Lahontan Regional Water Quality Control Board

Response to Comments on Draft Updated Requirements for In-situ Remediation Zones and Northwest Freshwater Injection System, Pacific Gas and Electric Company, Hinkley, San Bernardino County

Subject: Issuance of New Notice of Applicability of General Waste Discharge Requirements for In-Situ Remediation Zones and the Northwest Freshwater Injection System (WDID 6B360804007, Board Order R6V-2008-0014), Pacific Gas and Electric Company's Hinkley Compressor Station, San Bernardino County

Figure 1 IRZ Monitoring Well Performance Evaluation, Maintenance and Replacement Decision Tree

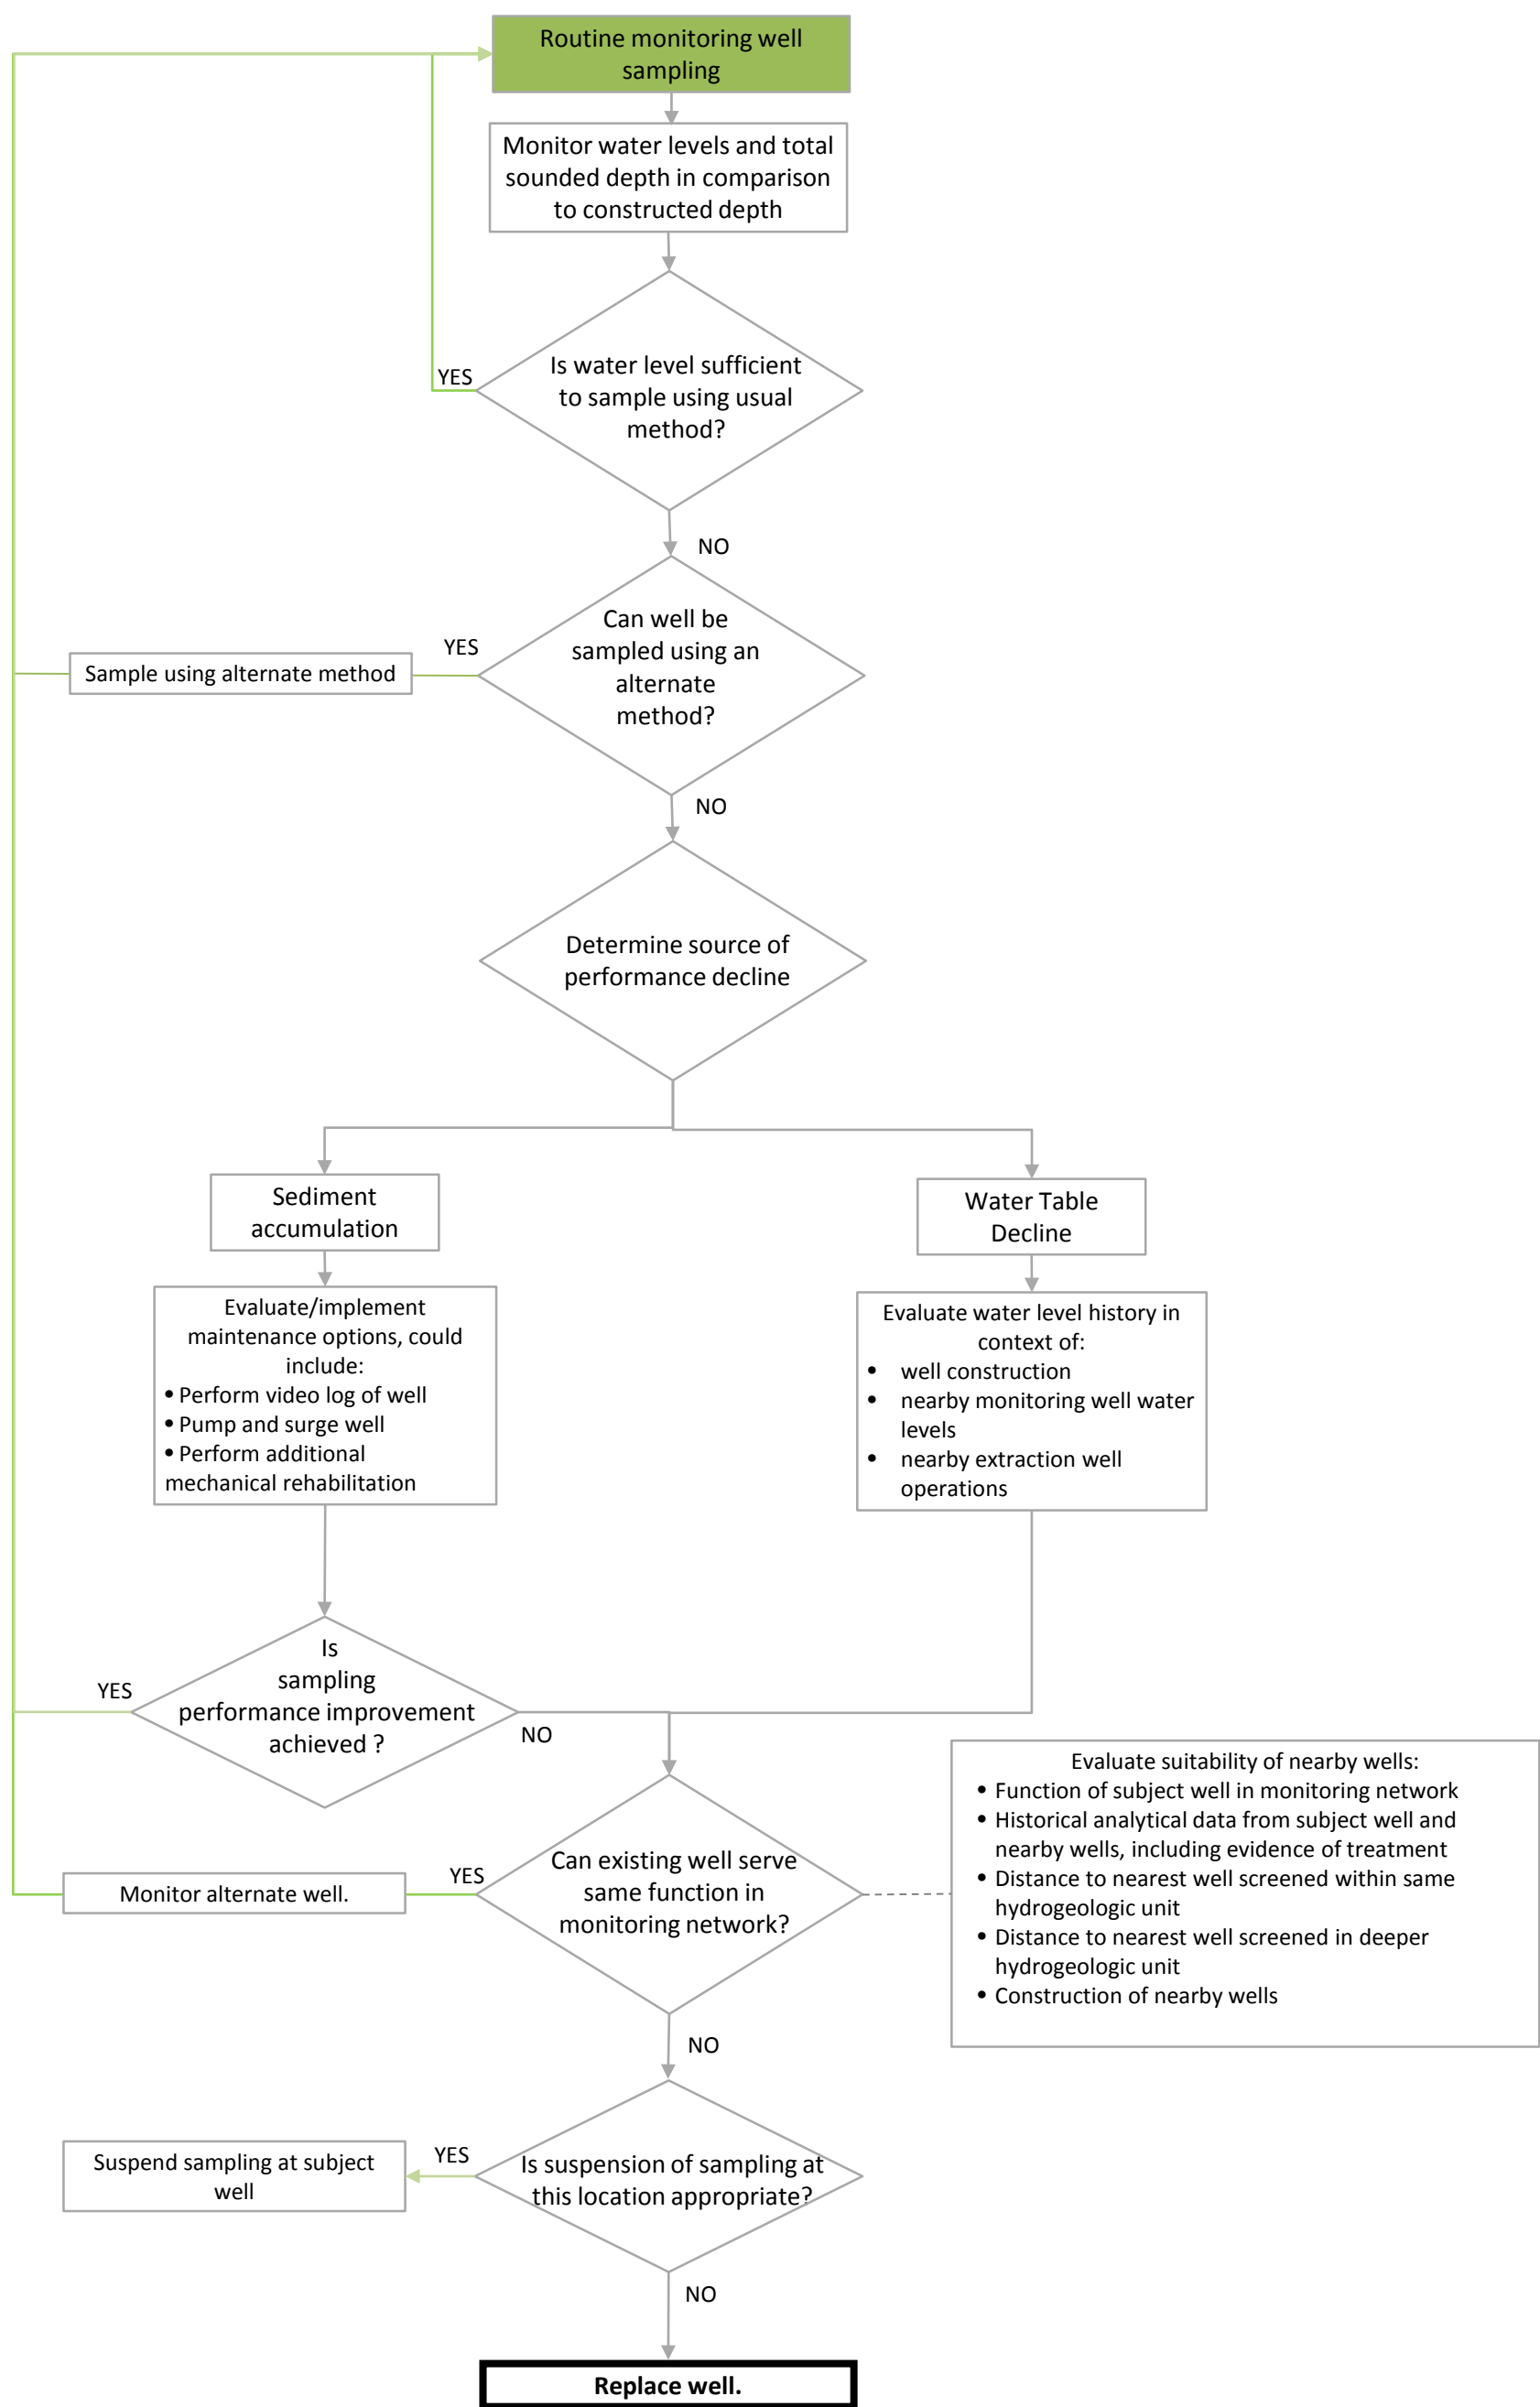
16. MRP, Section I.B.3, page 4. The Draft Monitoring and Reporting Program (MRP) for groundwater monitoring well sampling for IRZs states: “If any monitoring well required to be sampled under this MRP is dry for one year or more, it must be either re-developed or replaced such that a water sample can be collected.” PG&E recommends a case-by-case evaluation in the event that a monitoring well is unable to be sampled due to insufficient volume. This is recommended for several reasons. For example, the monitoring objectives may continue to be met by use of data from other nearby wells (e.g. a well within a short lateral distance or a deeper well beneath the dry well within the same hydrostratigraphic unit) or geologic conditions may not allow installation of a deeper well within the same hydrostratigraphic unit.

PG&E proposes that when a monitoring well has not been sampled for more than a year due to insufficient

water, the well will be assessed using the generalized decision tree provided as Figure 1. The water level, total sounded depth, and well construction information will be examined, and sampling using a different method may be attempted. If sampling is still not possible, a determination will be made whether the well cannot be sampled due to accumulation of sediment or due to a decline in the water table. If sediment has accumulated in the well, maintenance options such as video logging and redevelopment will be considered. If after the maintenance action sampling performance has not improved or if the water table has dropped locally to a point where sampling is not possible, then nearby existing wells will be evaluated to see if they are able to meet the monitoring objectives. Such factors as the function of the monitoring well in the monitoring network, well construction, the monitored portion of the aquifer unit, historical analytical results for the well and current results for nearby wells, and evidence of treatment at both the subject well and other nearby wells will be considered during evaluation. If a nearby well, including a deeper well at the same location, is able to provide data to meet the monitoring objectives it will be substituted into the monitoring network. If a suitable well is not identified to substitute into the monitoring network, a recommendation will be made whether to temporarily suspend sampling at the location or to replace the well. Temporary suspension of sampling may be necessary if the hydrologic unit has been dewatered. To implement this change PG&E suggests editing the language as follows:

“If any monitoring well required to be sampled under this MRP is dry for one year or more, it must be either re-developed or replaced such that a water sample can be collected an evaluation shall be submitted for each monitoring well that has gone dry regarding the potential need to replace that well in order to meet monitoring objectives. The evaluation should include an assessment of the likely causes for the well going dry and the proposed measures to meet monitoring objectives into the future.”

Response: This comment addresses both current monitoring wells that have been dry for more than one year and potential future monitoring wells that may go dry for one year or more. PG&E's suggested revision proposes to conduct an evaluation for each dry monitoring well to see whether monitoring objectives are still being met elsewhere. This proposal for an evaluation is reasonable for **future** potential dry monitoring wells, and should be initiated upon the second consistent dry monitoring event.

However, the proposed evaluation is not reasonable for current monitoring wells that have been dry for more than four quarters. For example, of the six monitoring wells that have been dry for four or more quarters, Board staff have already determined that five of them (CA-MW-313, CA-MW-412S, MW-61, MW-74S, SA-SM-03S) are in locations where the data is needed to verify remediation performance or threat to domestic wells on Mountain View Road; only SC-MW-11S is located where monitoring objectives can be met by another other nearby (<1,000 feet) monitoring wells. All of the five monitoring wells where data is needed have not been sampled since 2013. This absence of data needs to be addressed immediately by collecting a sample following re-development or installation of a new well. Therefore, MRP sections IB.3 and 4 are revised as follows:

3. If any monitoring well required to be sampled under this MRP has been dry for one year or more upon issuance of the NOA, such wells must be either re-developed or replaced such that a water sample can be collected within one-quarter's time. As of third quarter 2015, the following monitoring wells have been dry for four or more quarters, and must be re-developed or replaced because no other monitoring wells are located such that the monitoring

objectives of these wells can be met: **CA-MW-313, CA-MW-412S, MW-61, MW-74S, and SA-SM-03S.**

4. If any monitoring well required to be sampled under this MRP has been dry for two consecutive sampling events following issuance of this NOA, an evaluation shall be submitted for each monitoring well that has gone dry regarding the potential need to replace that well in order to meet monitoring objectives. The evaluation should include an assessment of the likely causes for the well going dry and the proposed measures to meet monitoring objectives into the future.
